PRELIMINARY HIGHWAY OBSERVATIONS FOR: 20/01656/CONS

HIGHWAY OBSERVATIONS FOR: 20/01656/CONS

Outline planning application with all matters reserved except for access for a mixed use sustainable urban extension on land to the South West of Milton Keynes to provide up to 1855 mixed tenure dwellings; an employment area (B1); a neighbourhood centre including retail (A1/A2/A3/A4/A5), community (D1/D2) and residential (C3) uses; a primary school and a secondary school; a grid road reserve; multifunctional greenspace; a sustainable drainage system; and associated access, drainage and public transport infrastructure. (Buckinghamshire Council's application 15/00314/AOP).

Figure 1: Forward visibility onto pedestrian crossing

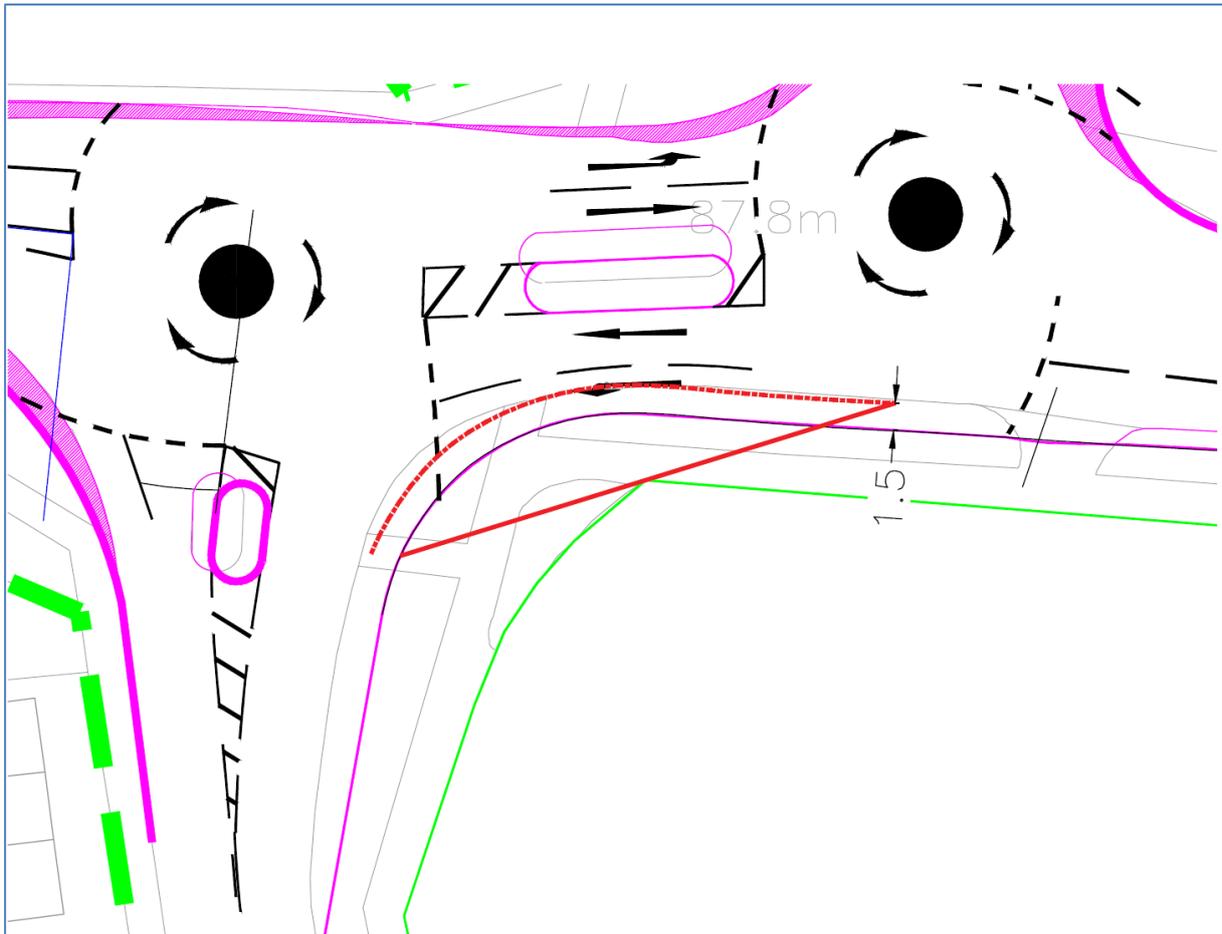
Under the proposals, the approach from Newton Road (southern arm) aims drivers in the right hand lane directly at the central island. This could make manoeuvring around the island difficult.

The forward visibility to pedestrians waiting to cross on the eastern side of Newton Road is worsened by the proposals. Taking an MfS SSD (given the speeds and environment), there is currently space to accommodate an approximately 41.9m SSD to the centre of the footway at the crossing. Under the proposals this is reduced to approximately 31.9m (both distances measured along the driver's path), as shown below:

In summary, the scheme drawings are incomplete and unacceptable for planning determination purposes, and the proposed mitigation would not address the severe / unacceptable impact of development traffic.

Figure 2: Roundabout exits blocked by HGVs

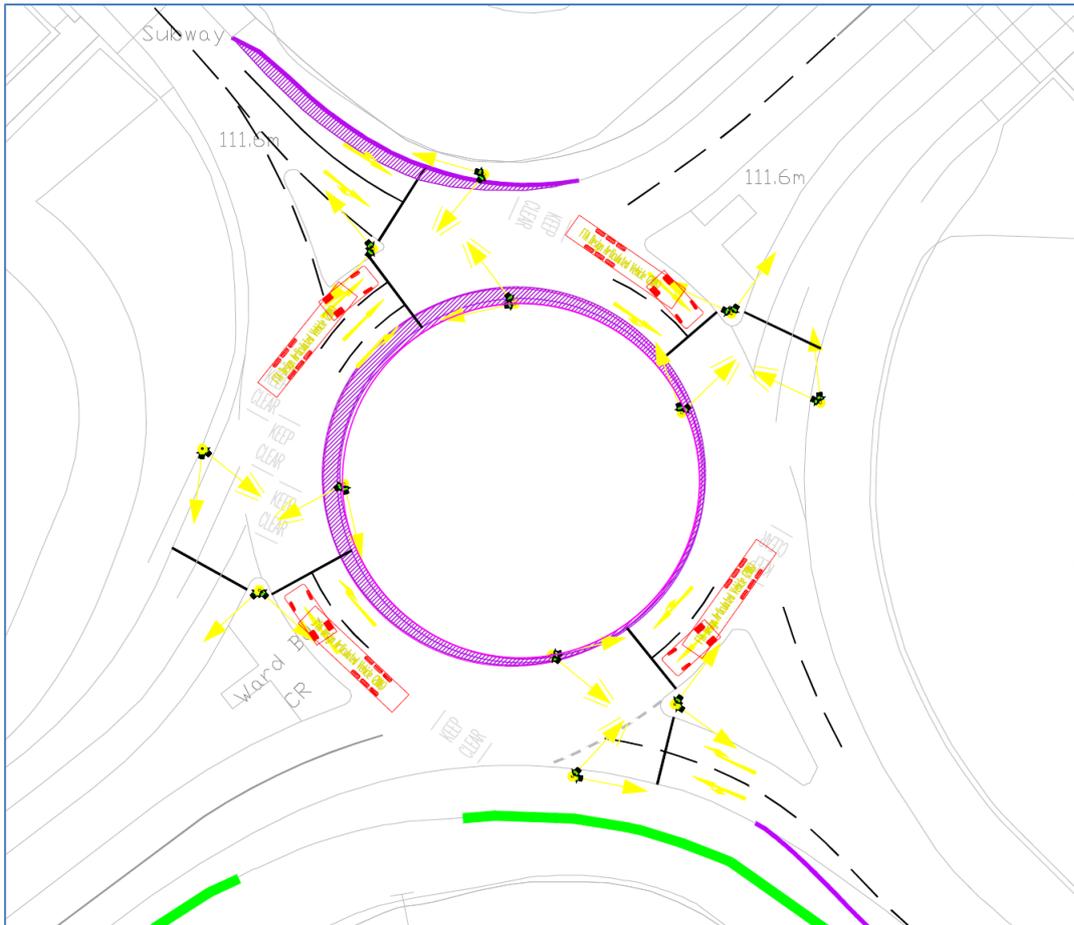
In any case, an articulated HGV stopped at the lights would completely or partially block the exits of the roundabout as shown in Figure 2:

Keep Clear markings have been proposed to mitigate against this potential blocking back. Given that the junction is signalised and would be congested at busy periods, it is unlikely that these markings would be observed by drivers and they are not enforceable.

The gyratory lane lengths in the model would still need to be updated so that vehicles could not extend back onto these markings - this would reduce the stacking capacity of 16-20m to c.10m, sufficient for 1-2 PCUs, below both the UQ and MMQ measurements.
